ADDENDUM No. 3

**ORG #207 – San Jacinto Elementary School - Renovation
ORG #273 – Pleasant Grove Elementary School – Renovation**

DALLAS INDEPENDENT SCHOOL DISTRICT

11/01/2024

1 ROOF PLAN
Scale: 1/16" = 1' - 0"

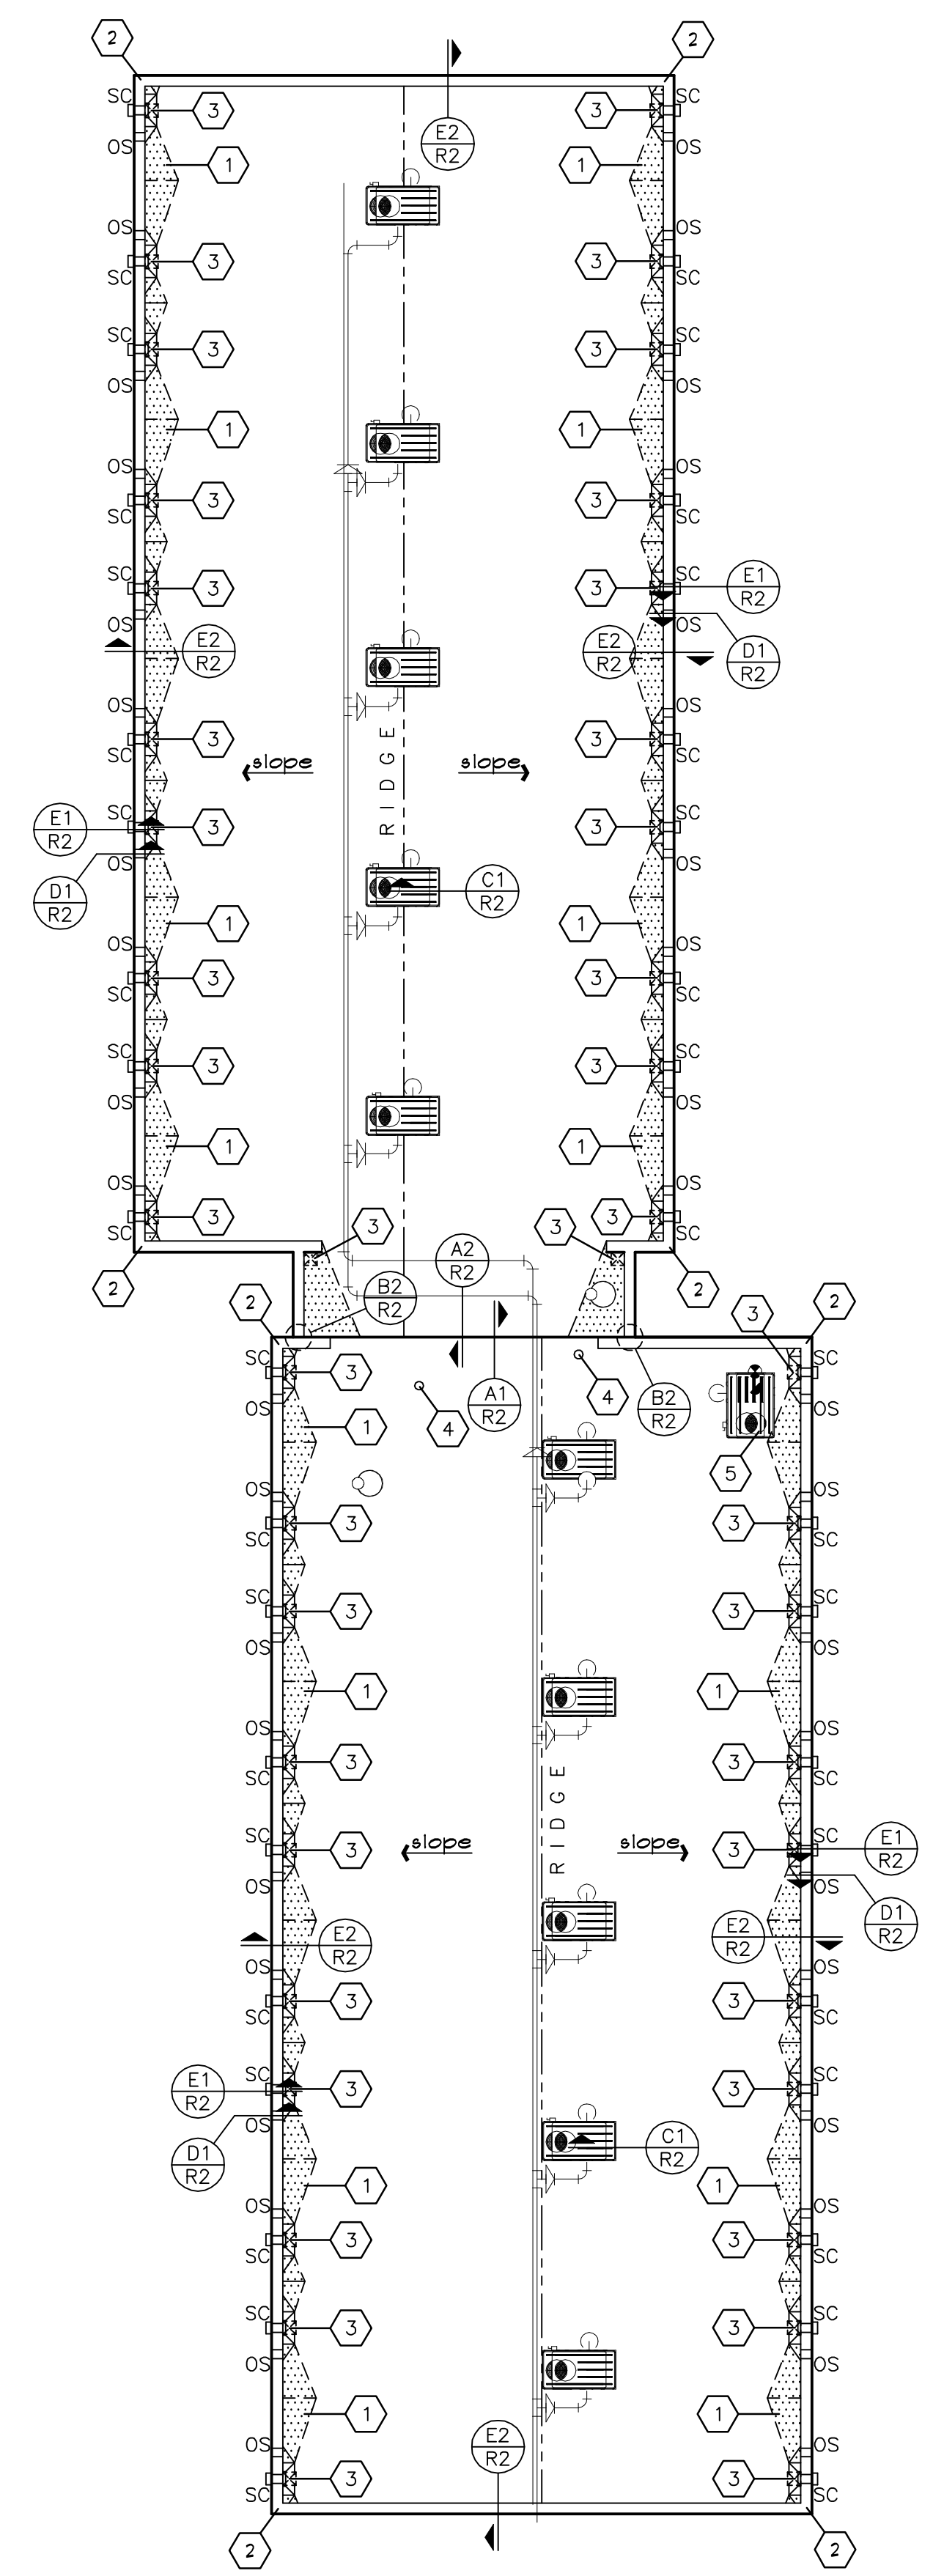
- Question: How many overflow scuppers are needed for the roof project?
 - Response: Refer to sheets R1 and R2.
- Question: What is the curb height of the (2) RTUs that are not being replaced and will those curbs need to be replaced?

- Response: Refer to sheet R1 and R2 details for scope of work.
- Question: Are the missing / damaged rooftop motion detectors to be replaced on the modular buildings?

PARTIAL MECHANICAL ROOF PLAN 'B1'

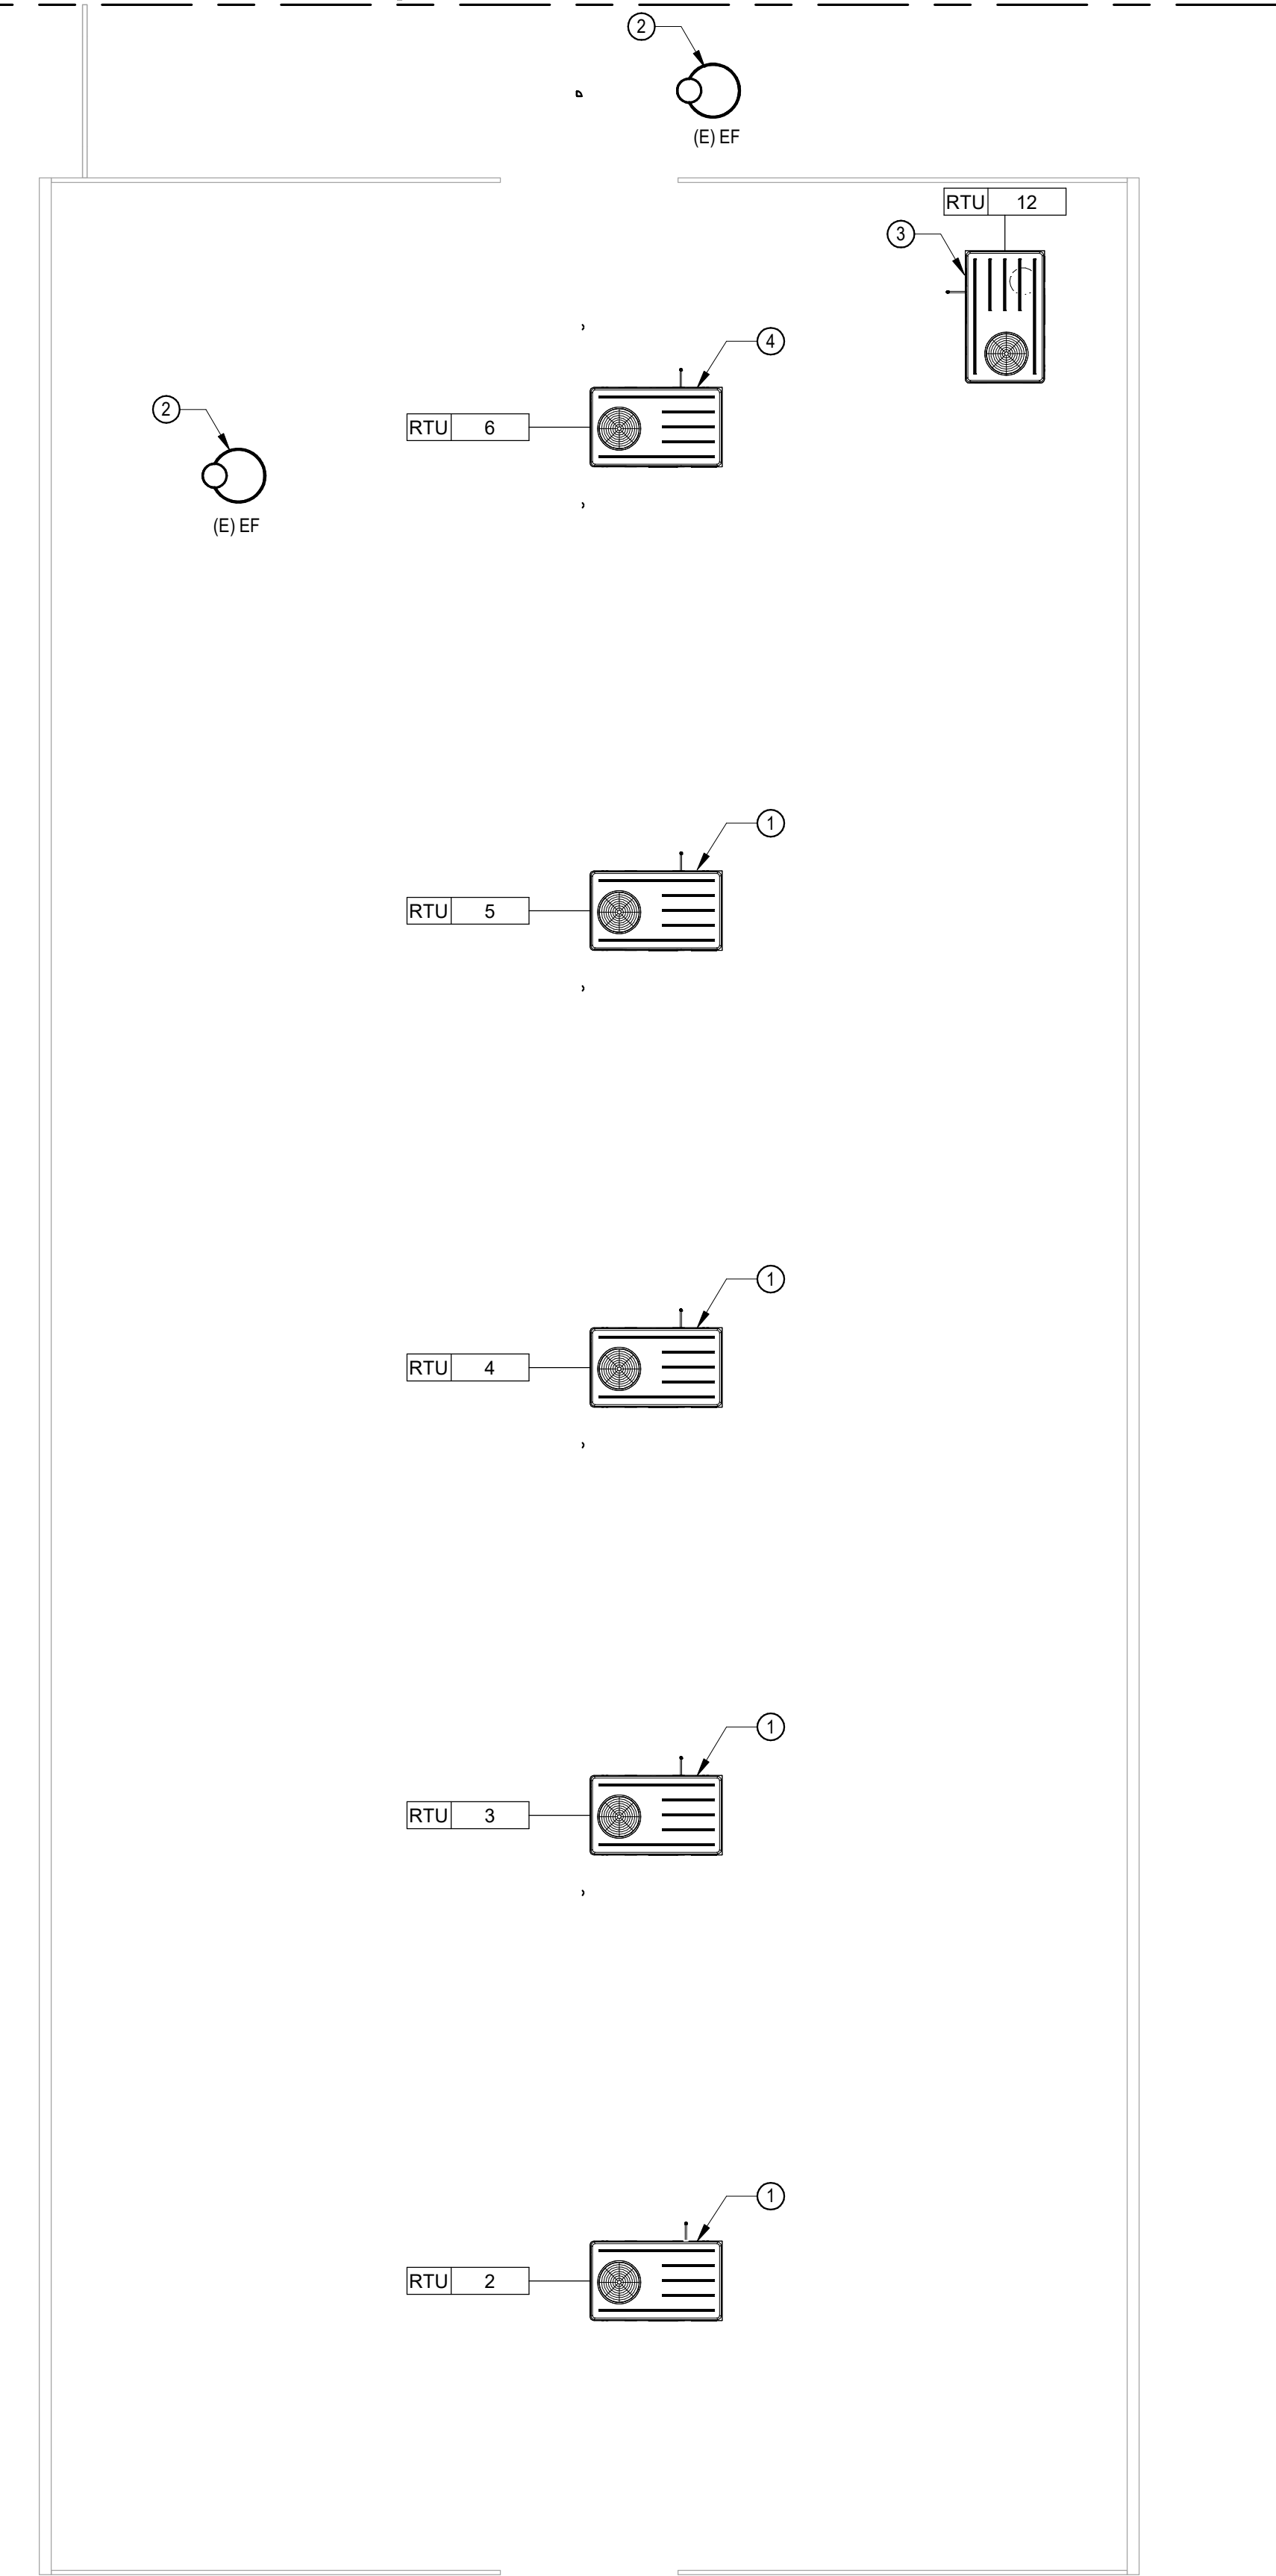
- Pathway notes added.
 - Exterior 360-degree camera location added.
 - New motion beam detector locations and new panel
- Replace sheet with the revised attached M1.33.

- Updated note #3 to include fall protection for units less than 10’ from roof edge as indicated.
- Replace sheet with the revised attached P1.31 and P1.32.
